**ADDENDUM
NO. 3**

September 11, 2024

**LOGANSFORT JR. HIGH SCHOOL RENOVATIONS
Logansport, IN 46947**

© GIBRALTAR DESIGN SHEET
B ED105

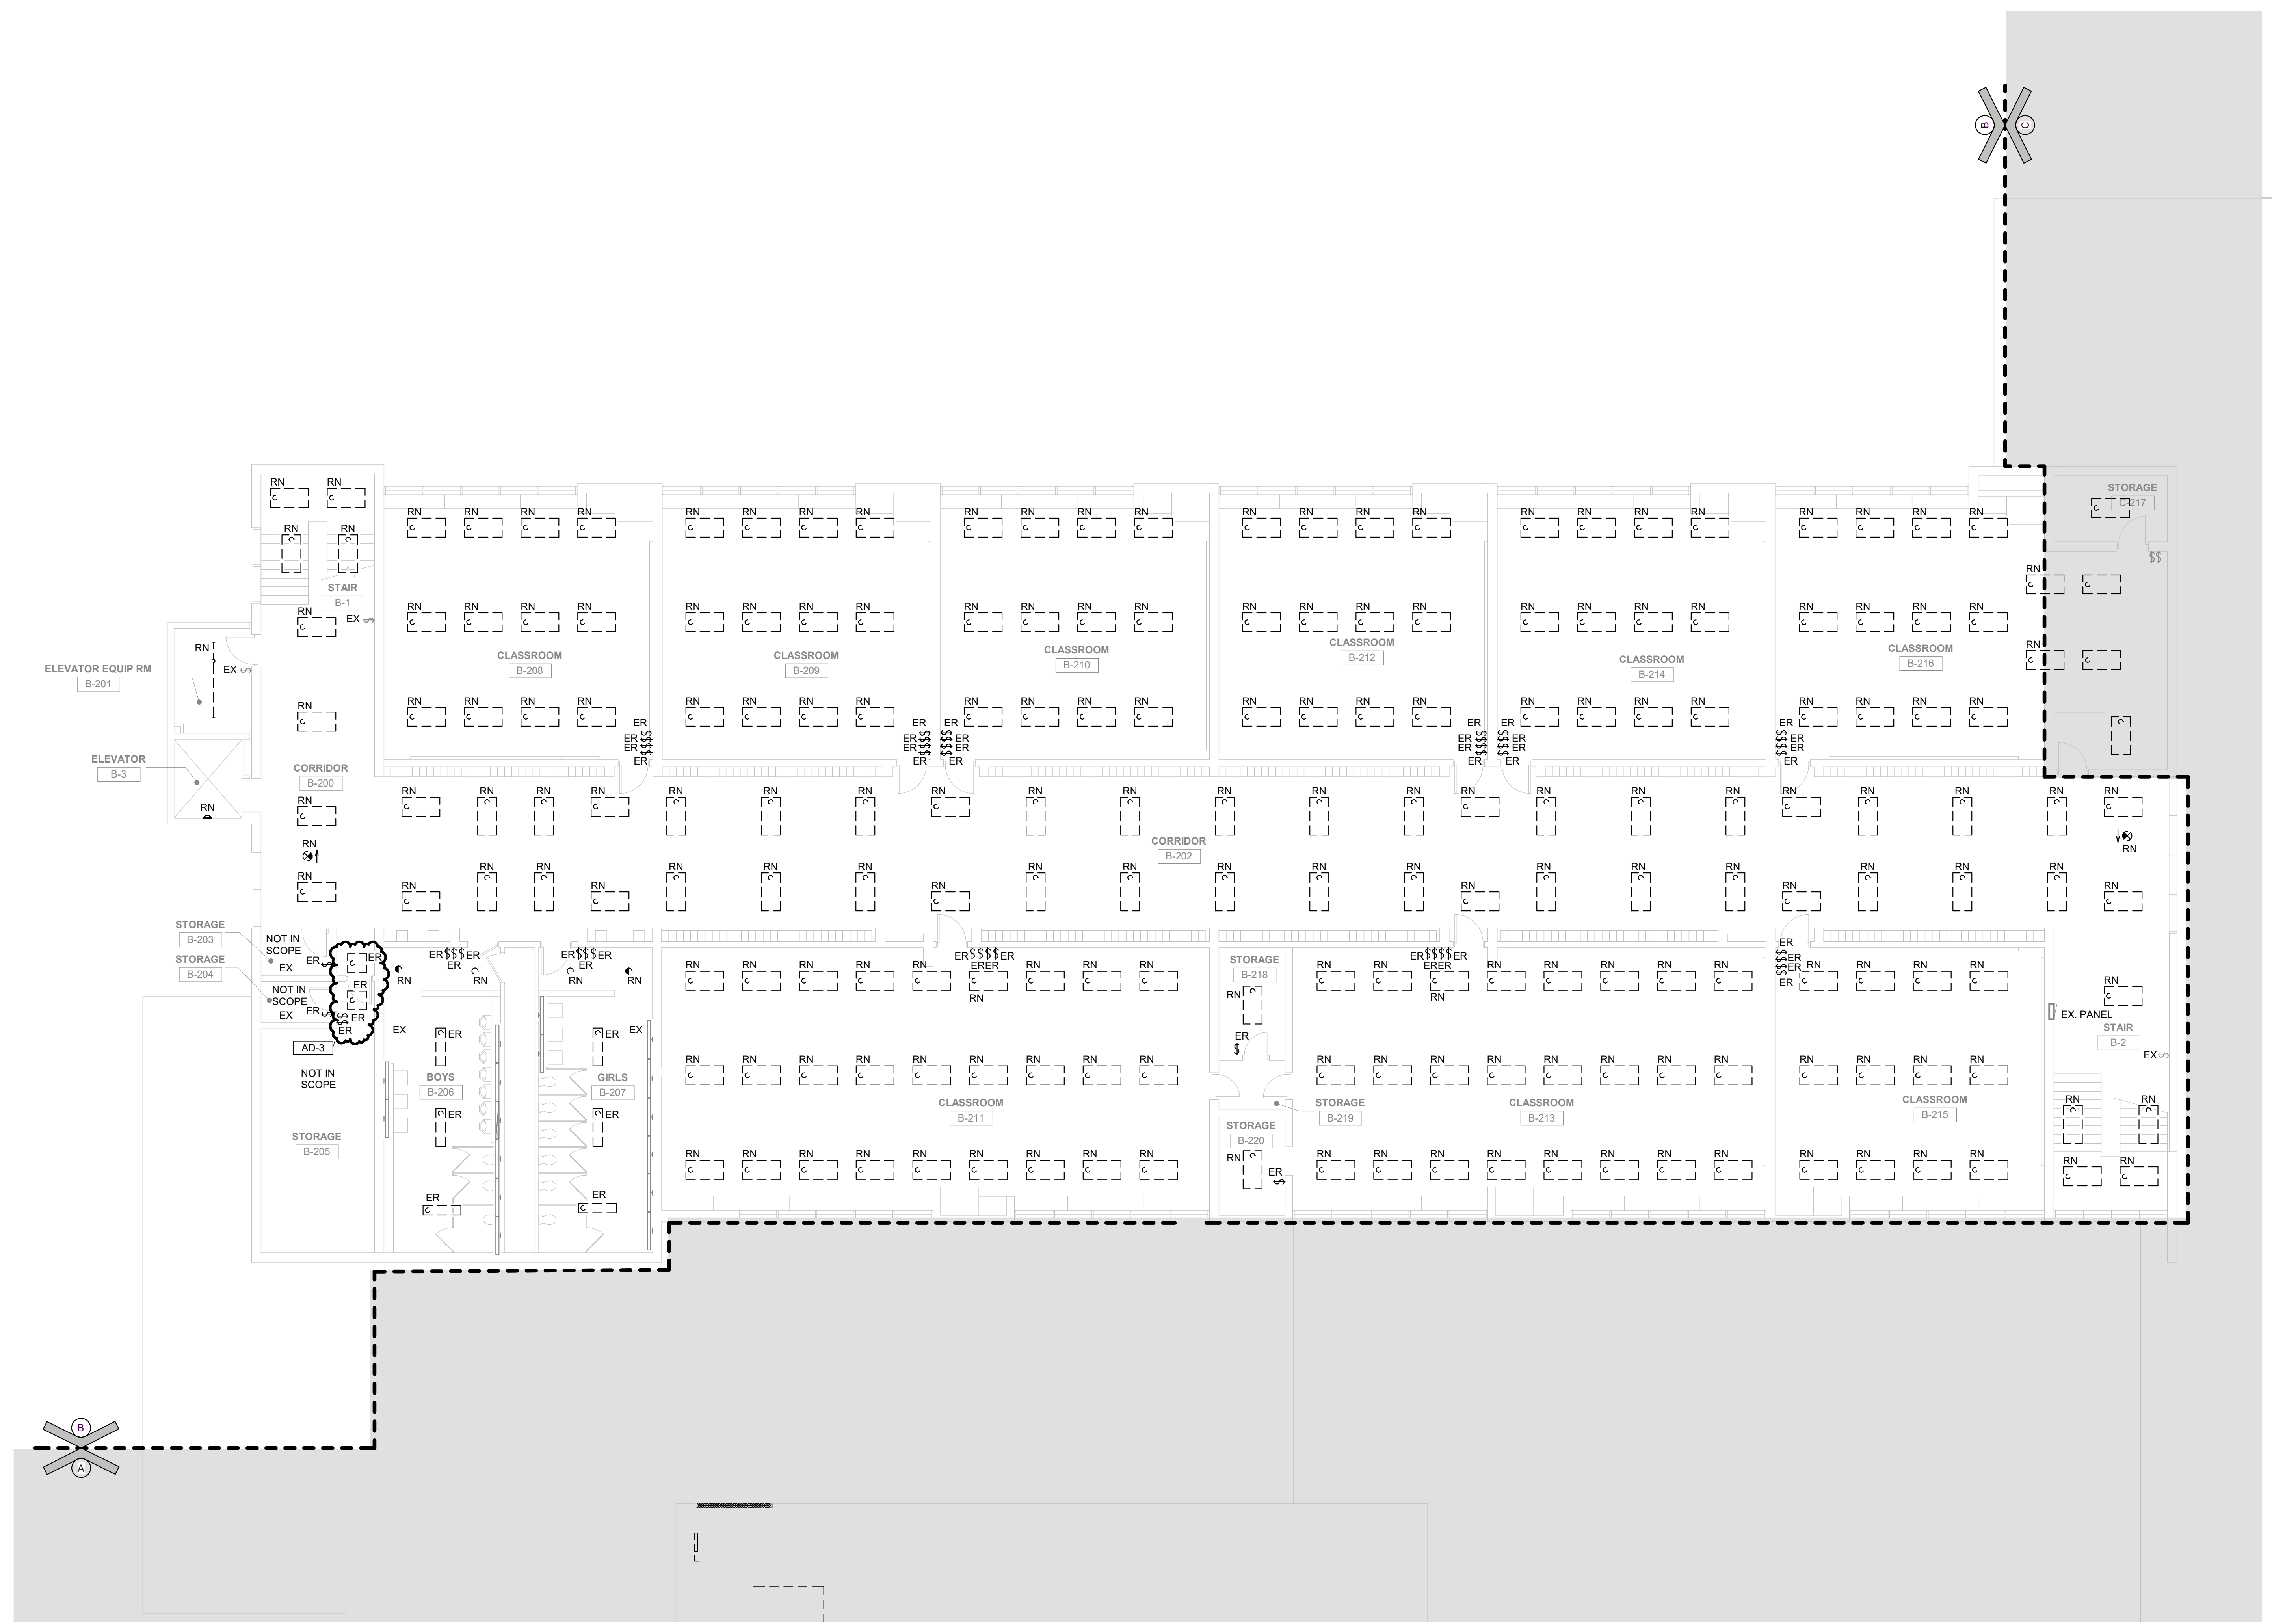
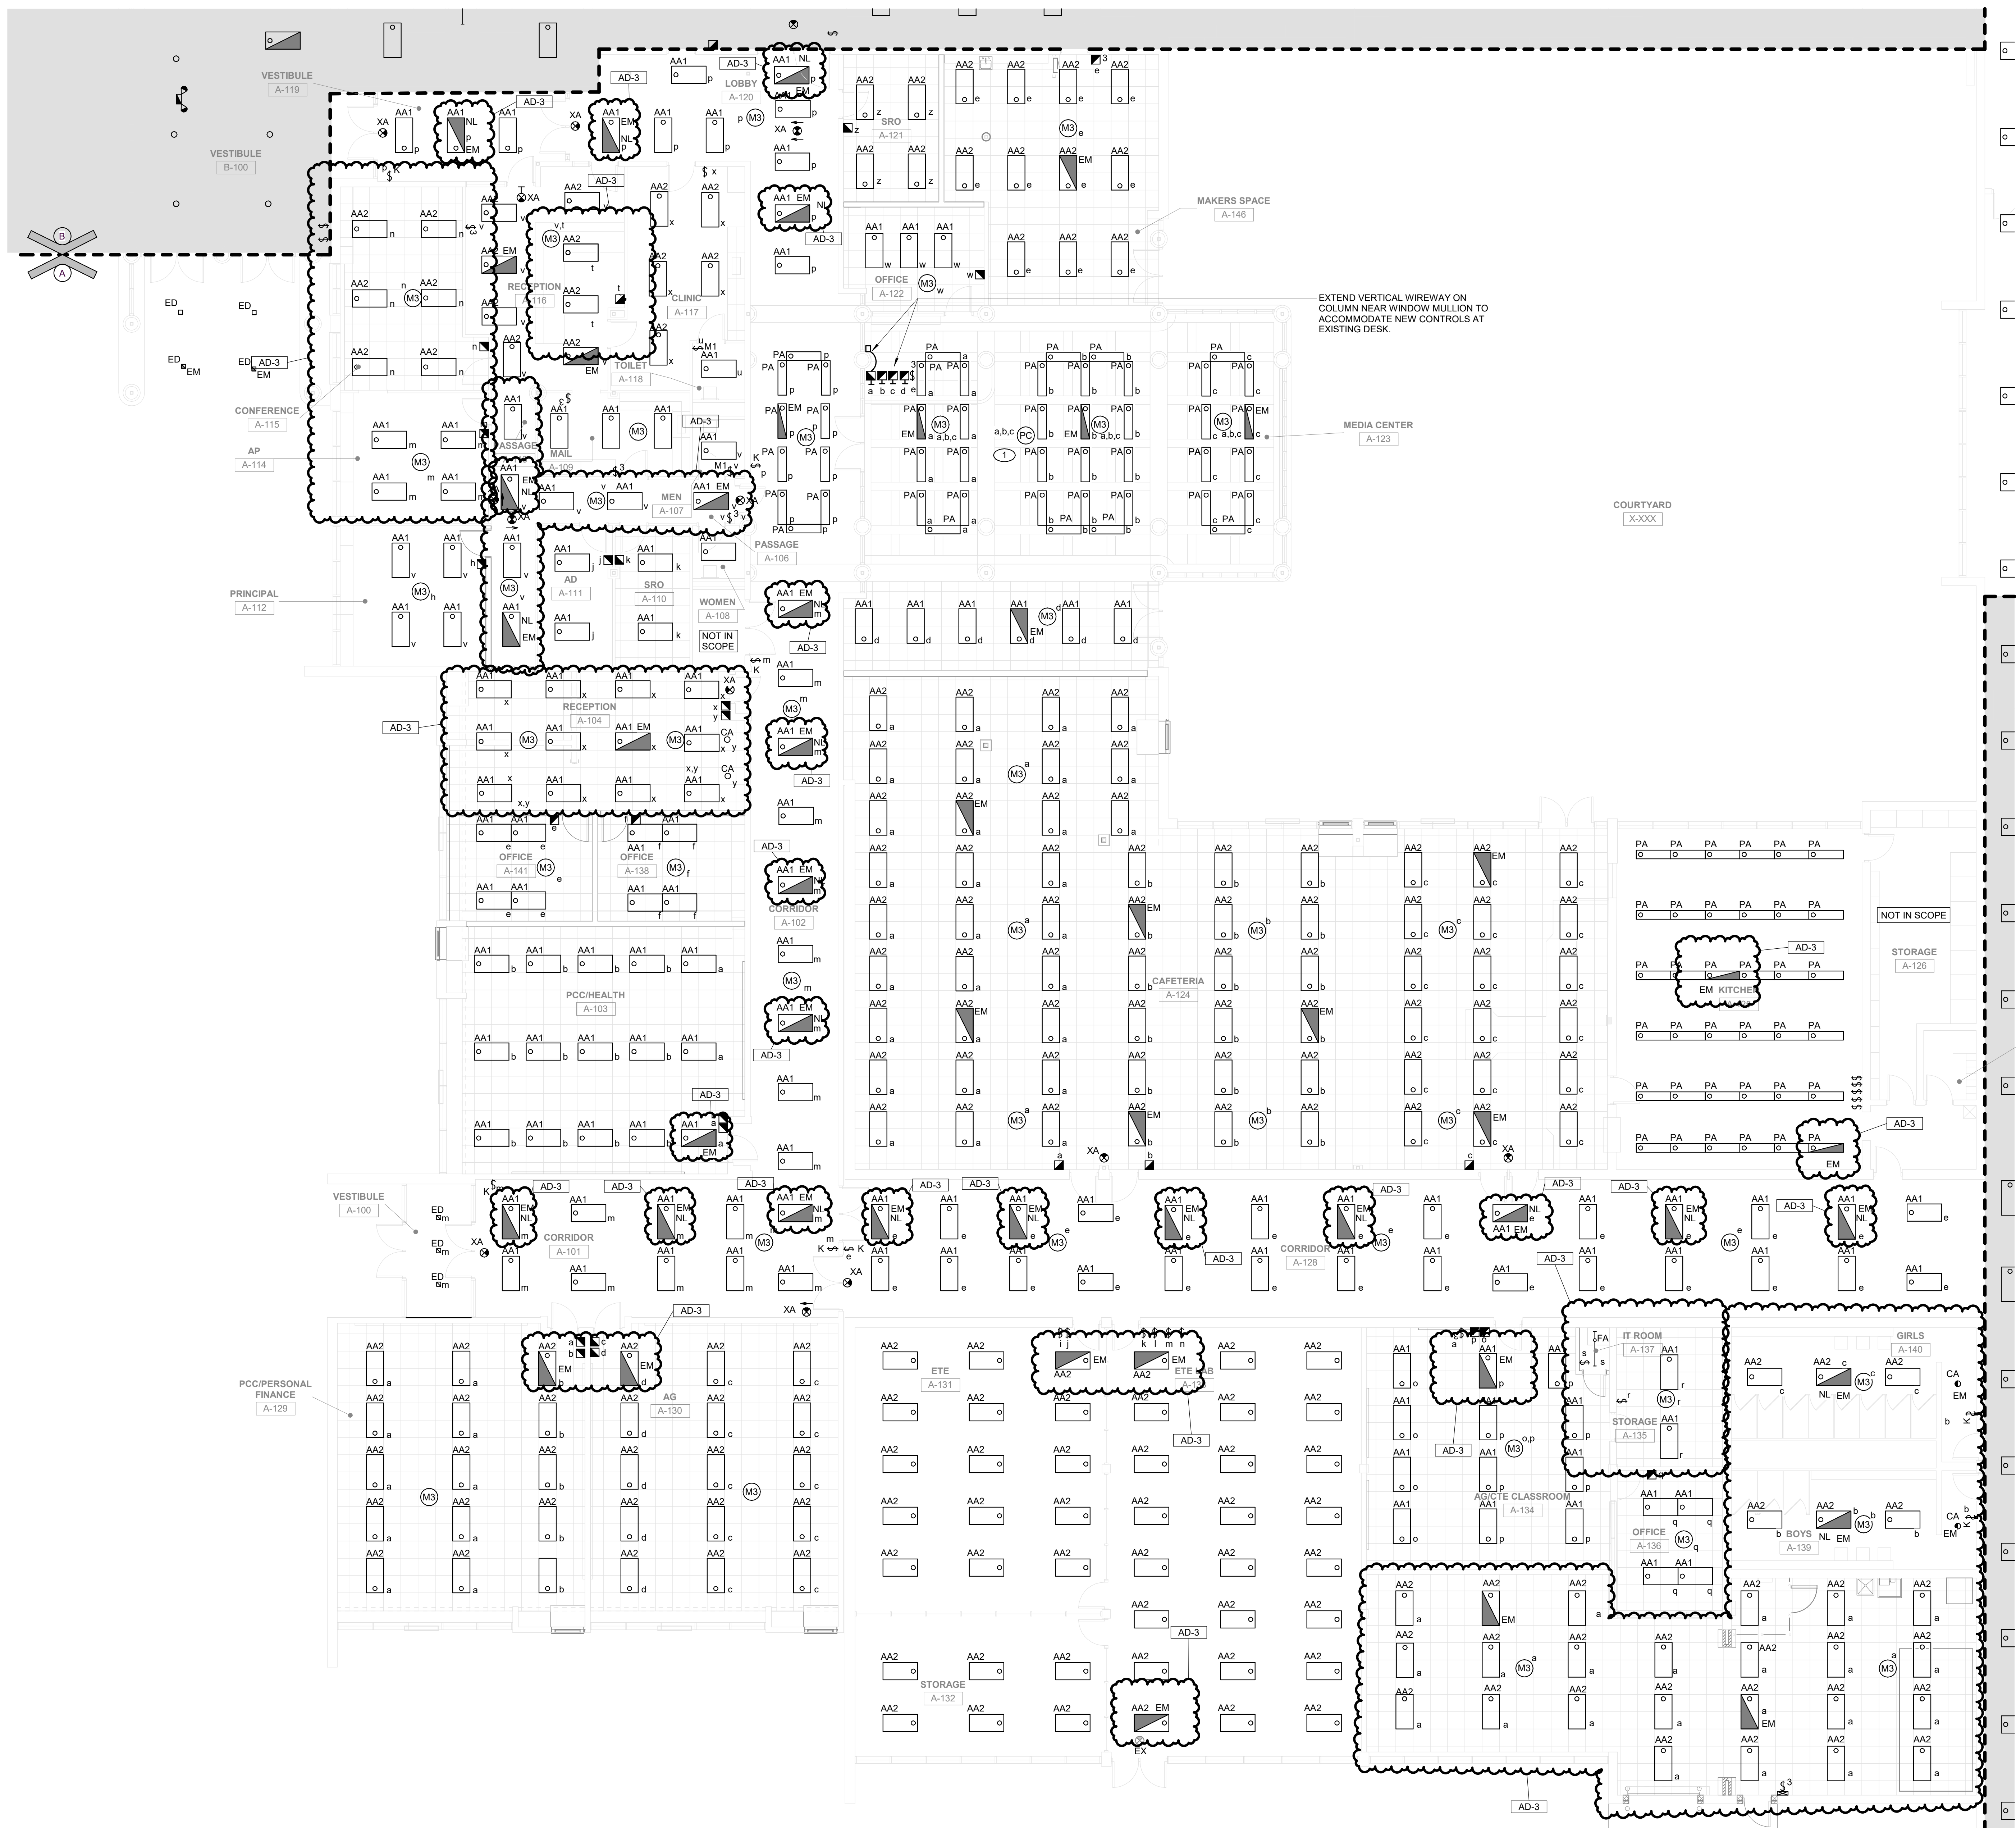
- A. Added low voltage demo scope.
- B. Added demo scope.

GIBRALTAR DESIGN SHEET
B EL102

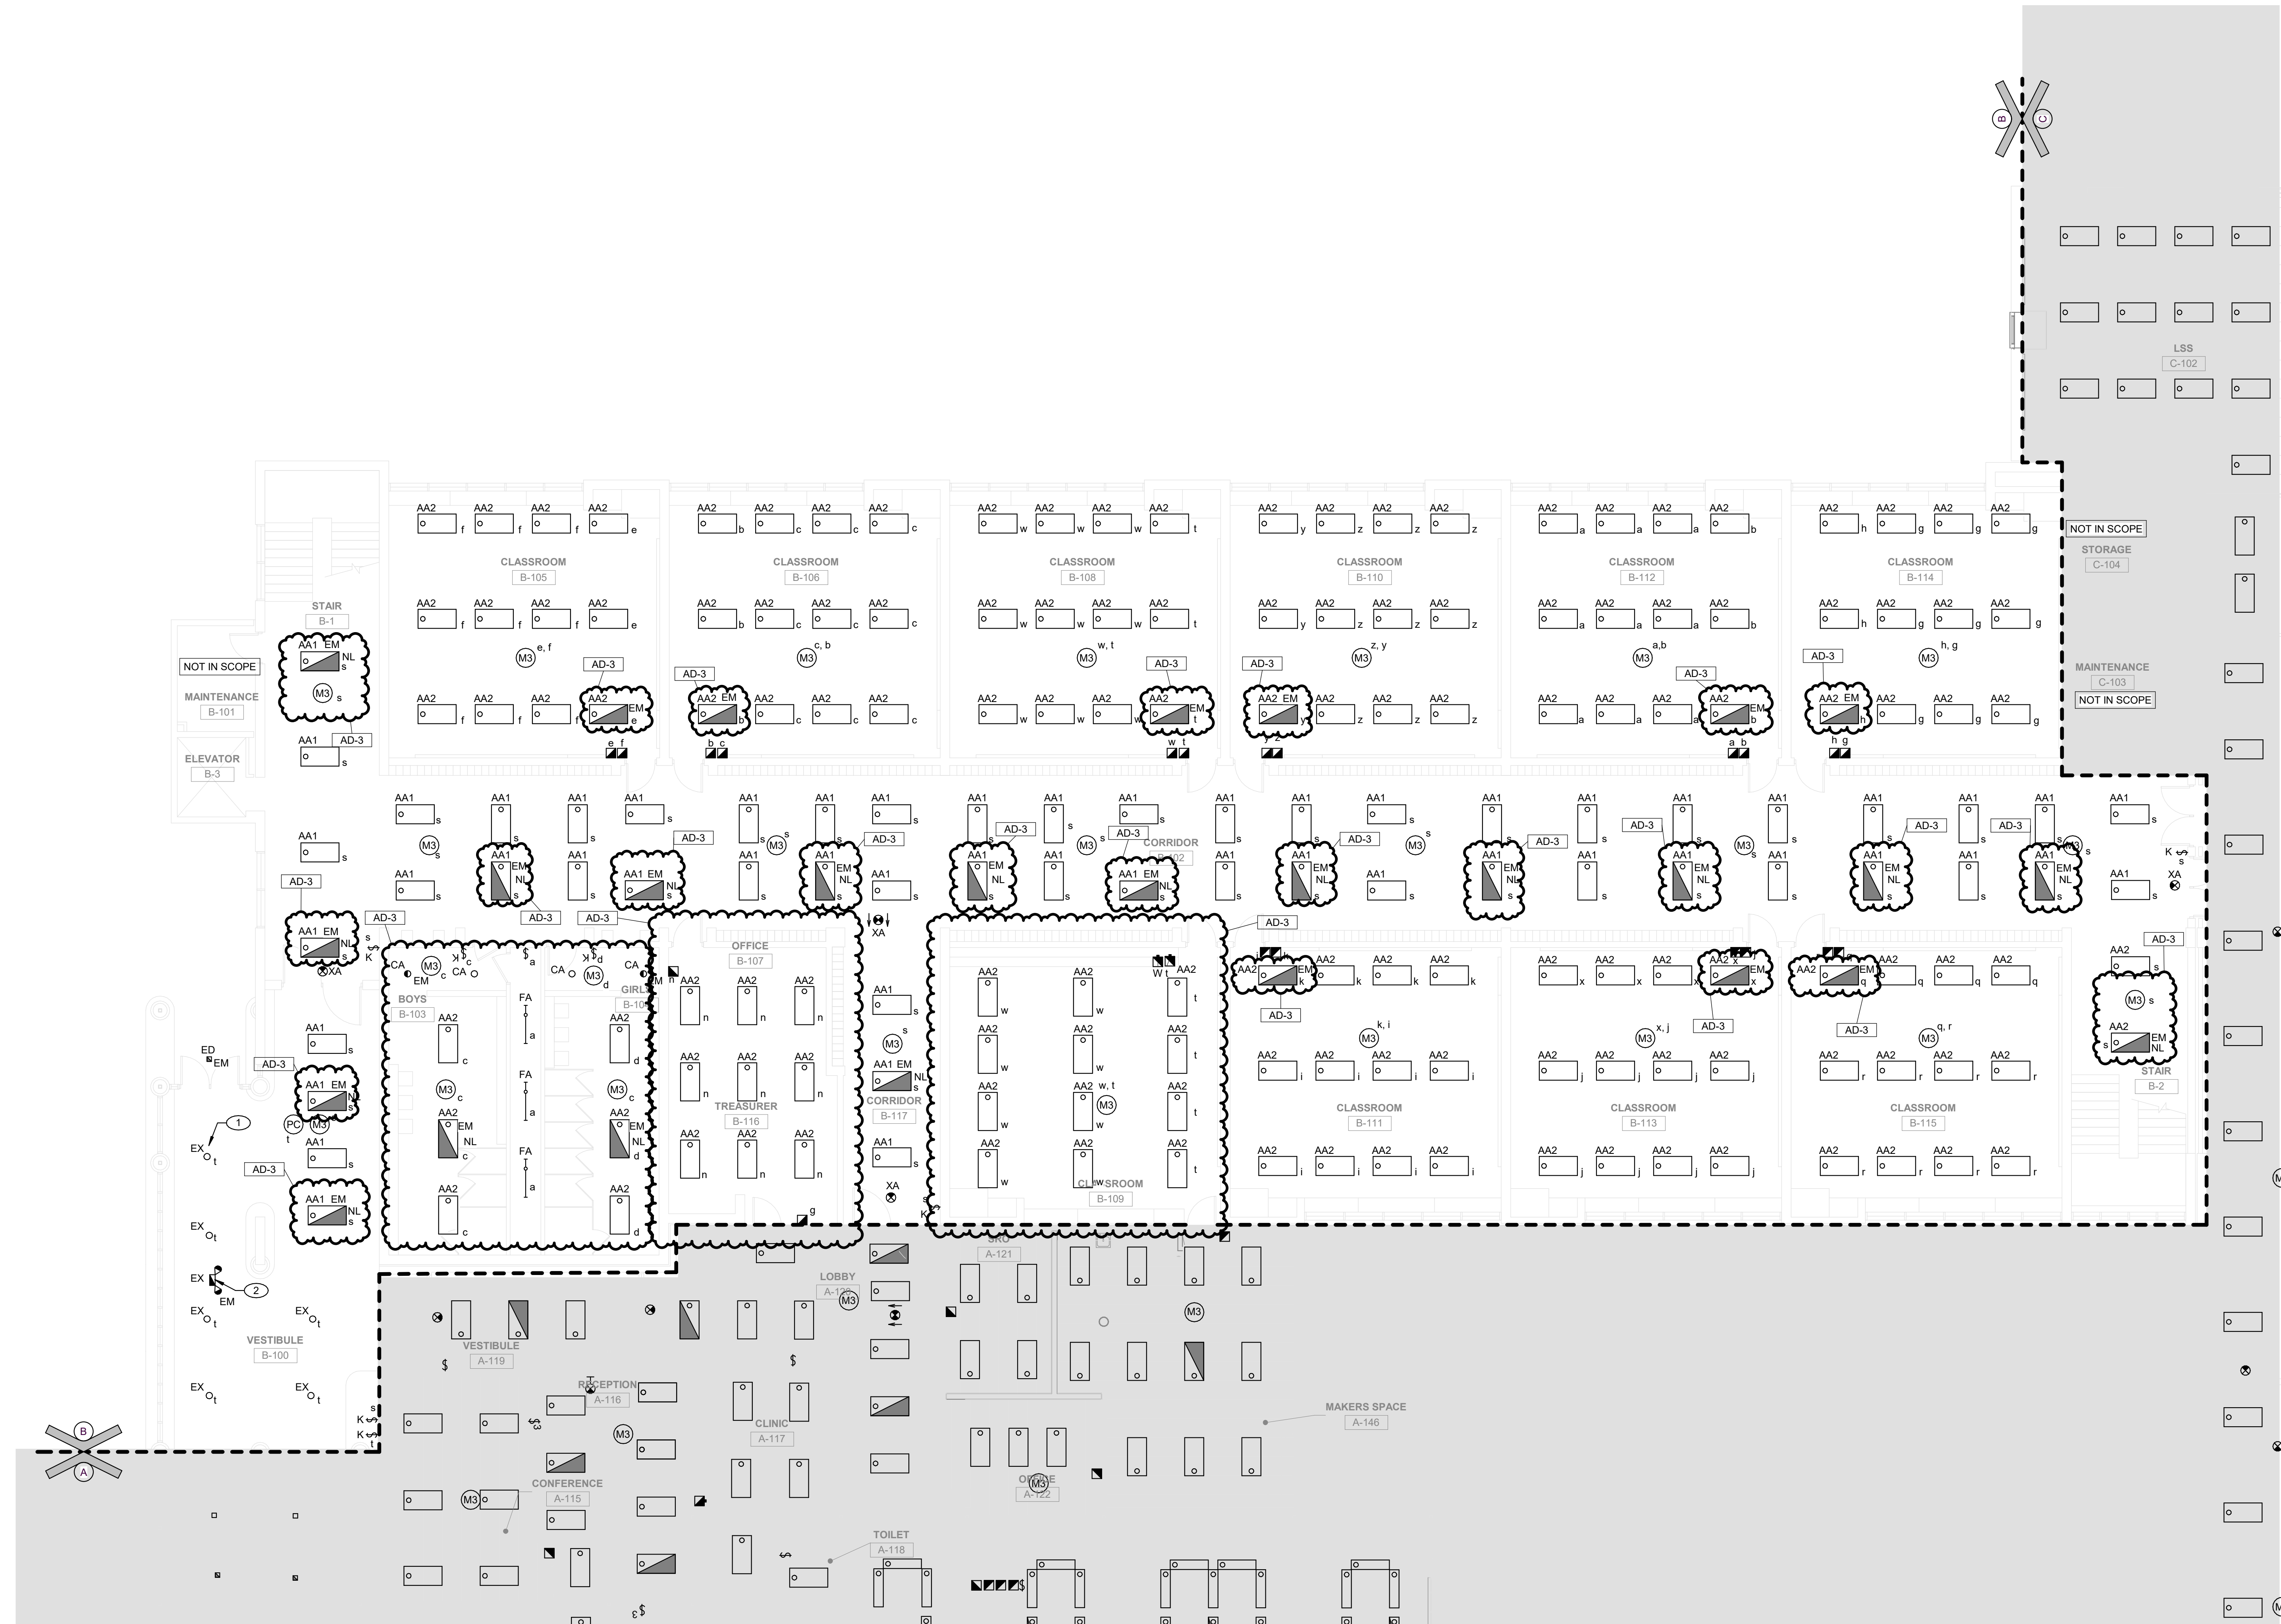
- A. Added emergency lighting in all classrooms and boys/girls' toilets.
- B. Revised lighting scope including layout in Treasurer B-116 & Classroom B-109.
